Re: Matter of the Application of Hydro Resources Inc., Docket No. 40-8968-ML,  
ASLBP No. 95-706-01-ML

**INTERVENORS' RESPONSE TO HYDRO RESOURCES INC.'S COST ESTIMATES  
AND RESTORATION ACTION PLAN OF NOVEMBER 21, 2000**

**WRITTEN TESTIMONY OF MR. STEVEN C. INGLE IN SUPPORT OF  
INTERVENORS' RESPONSE TO HYDRO RESOURCES INC.'S COST ESTIMATES  
AND RESTORATION ACTION PLAN OF NOVEMBER 21, 2000**

Figure 2.7. Schematic flow diagram and approximate flow rates of restoration wastewater treatment systems.

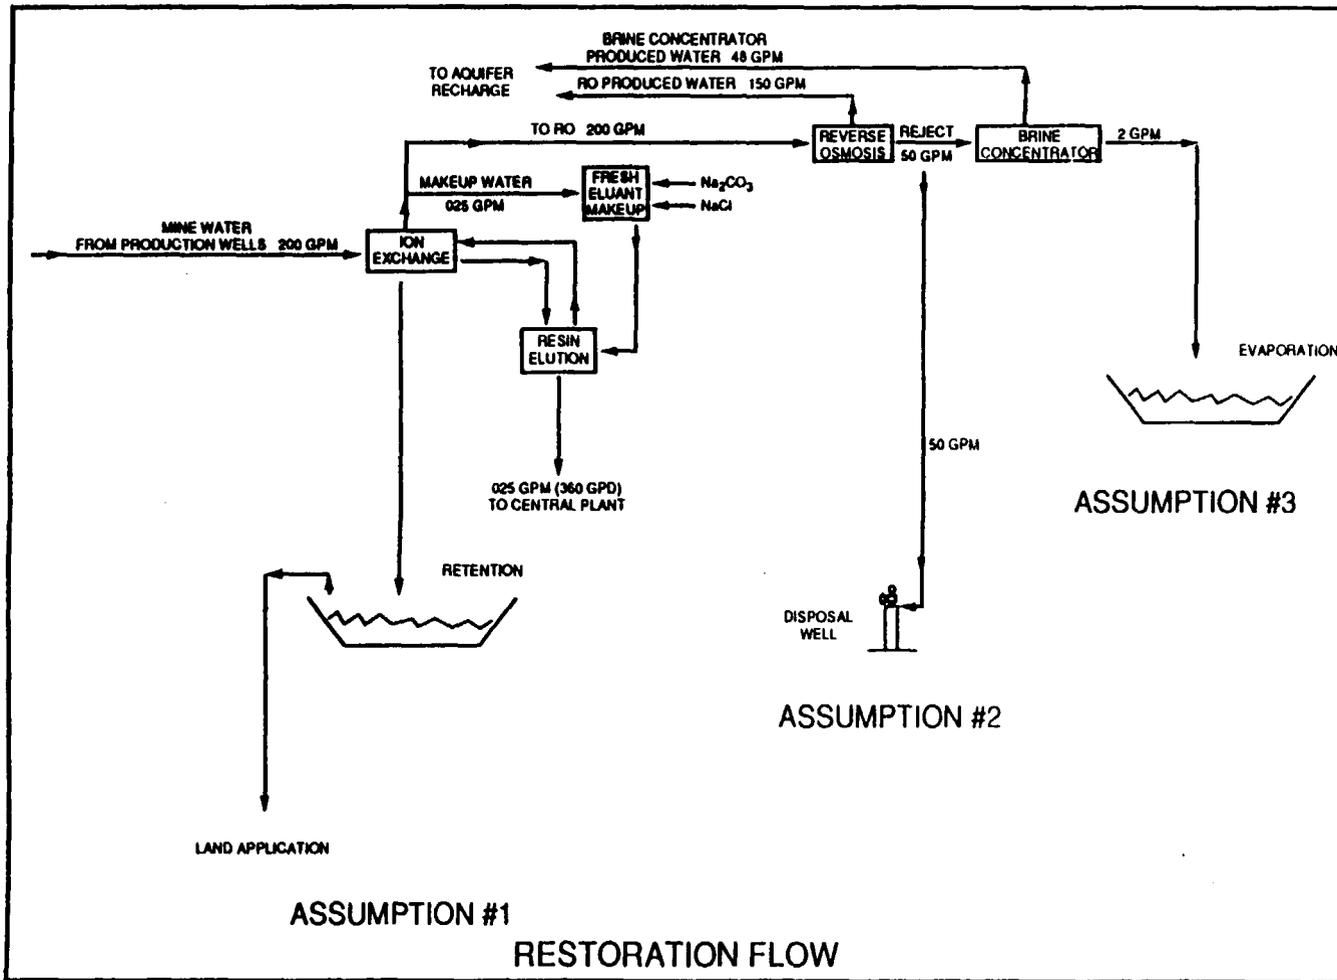
described in HRI's August 1997 Consolidated Operations Plan (Figure 10.4-1 at COP-162) and in the NRC's FEIS (Figure 2.7 at 2-22). In the COP and the FEIS, restoration flow diagrams were provided to show where the mining solutions were routed and how many gallons per minute of waste water were treated at each step of the process. I have copied these diagrams and included them in **Attachment E** attached hereto. In these diagrams, the RO unit generates 50 gpm of "reject" water (or 25% of the total flow) that enters the BC. In the RAP (which does not contain a similar flow diagram), 116 gpm of RO reject water (or 20% of the total flow) enters the brine concentrator. HRI does not discuss why the amount of restoration water entering the system has nearly tripled in the 3-plus years that have elapsed since the FEIS and the COP were prepared.
